Review and Refinement of ATC 3-08 Tentative Seismic Provisions

Report of Technical Committee 4: Concrete

October 1980

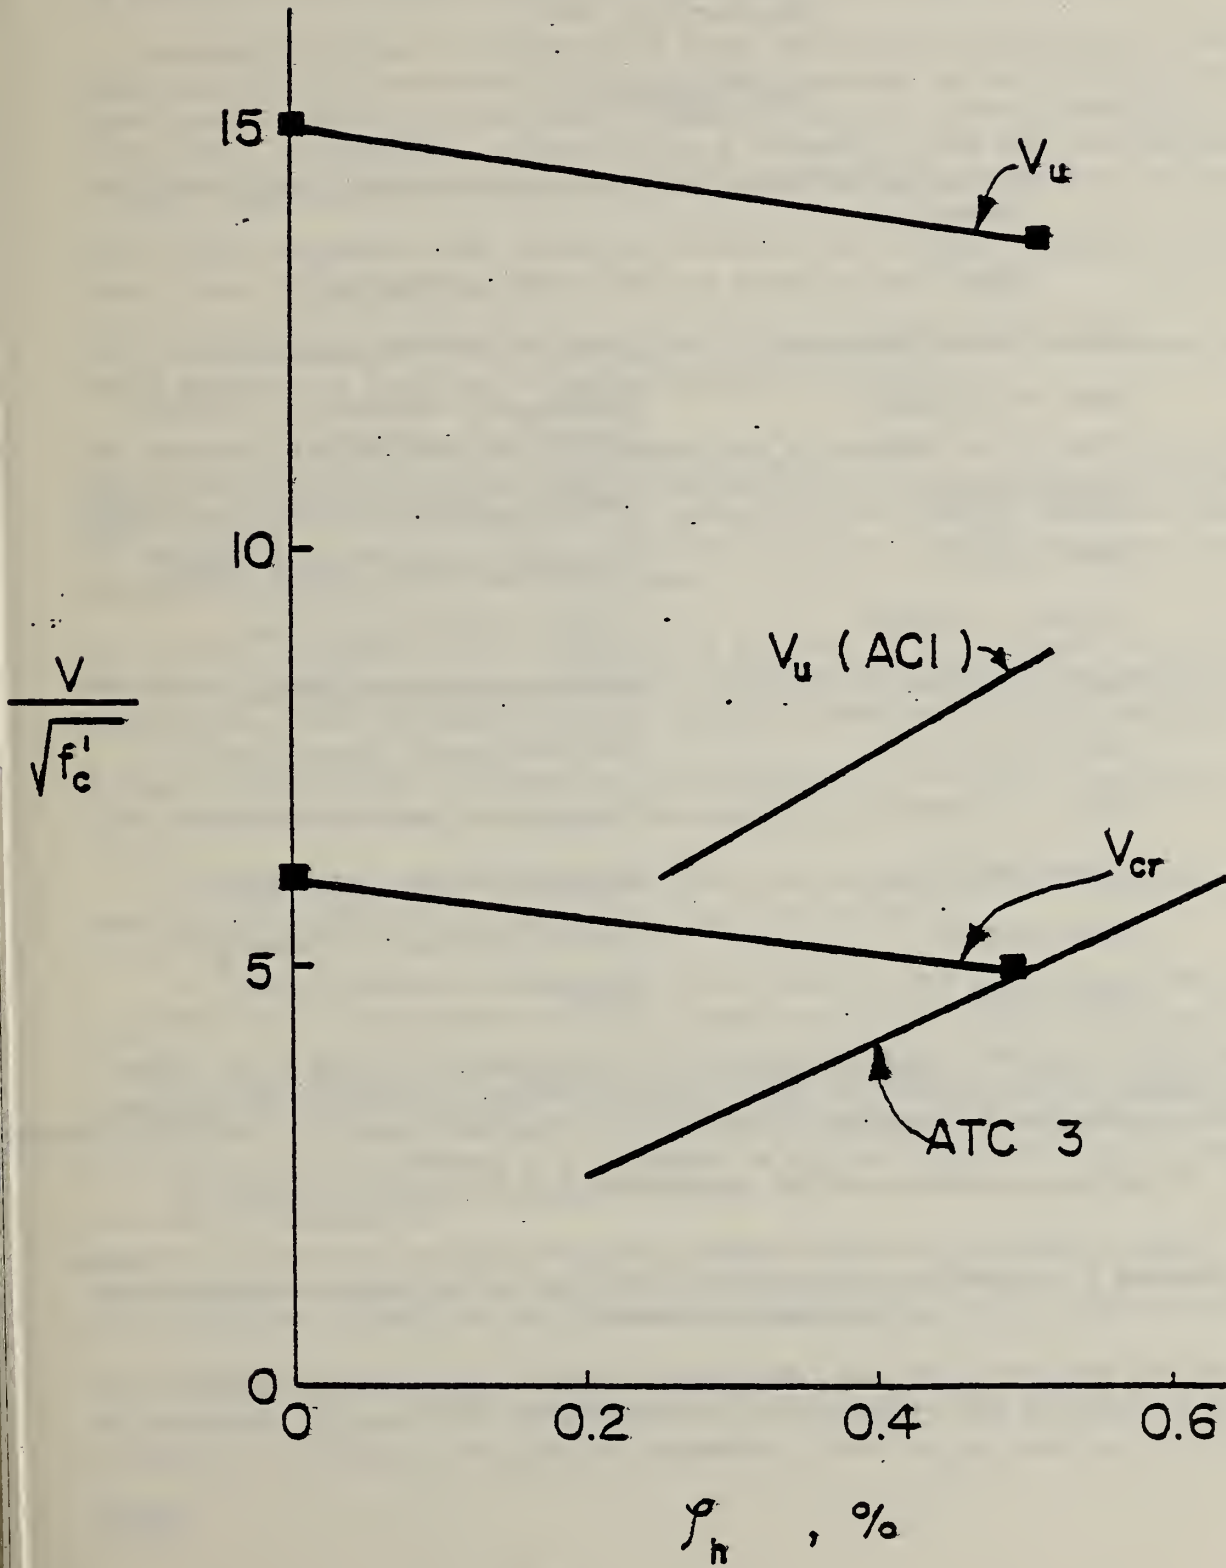
One of the most restrictive suggestions in Chapter 11 is Equation 11-5. The enclosed graph shows the proposed ATC-3 design requirement compared with results of tests on short walls. On the ordinate, shear strength is plotted, and on the abscissa, the amount of horizontal reinforcement. The top line indicates measured strength, the line marked v_u (ACI) is strength permitted by ACI 318-77, the line marked v_{cr} is the observed cracking strength and the bottom line is the strength proposed by ATC-3. As can be seen, at ultimate load the walls would have a load factor of 1.5 or more against cracking. The load factor on strength could be as high as 14.

Fig. A - Reinforcement Details
Satisfying Section 11.4.1 (E)

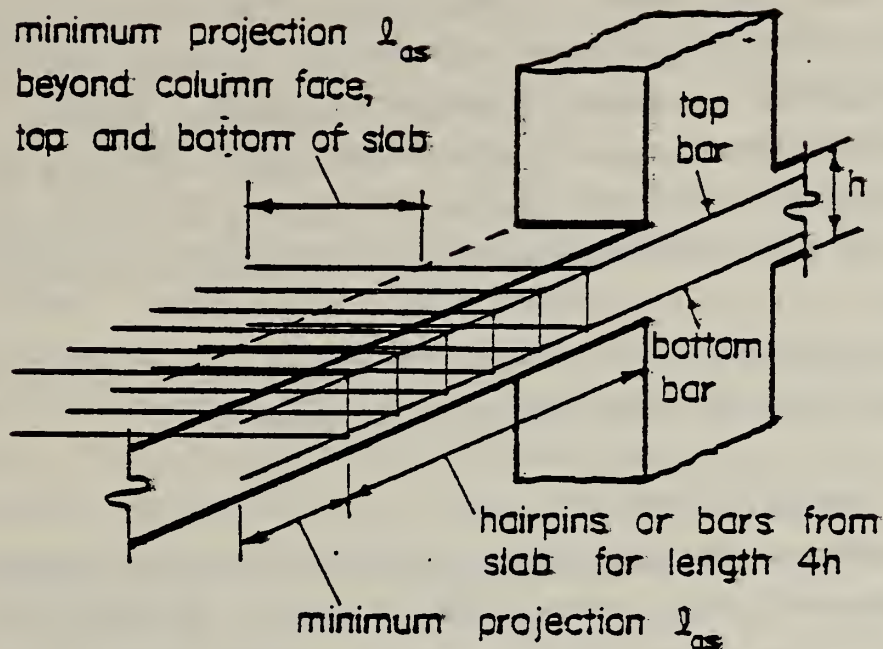
As shown in Fig. A there should be top and bottom bars in the slab paralleling and as close to the discontinuous edge as possible, continuous through the column and enclosed within transverse reinforcement having a spacing not greater than $0.5d$. The transverse reinforcement can be closed hoops, hairpin stirrups projecting ℓ_{as} beyond the face of the column as shown in Fig. A or slab bars bent to satisfy the requirements for hairpin.
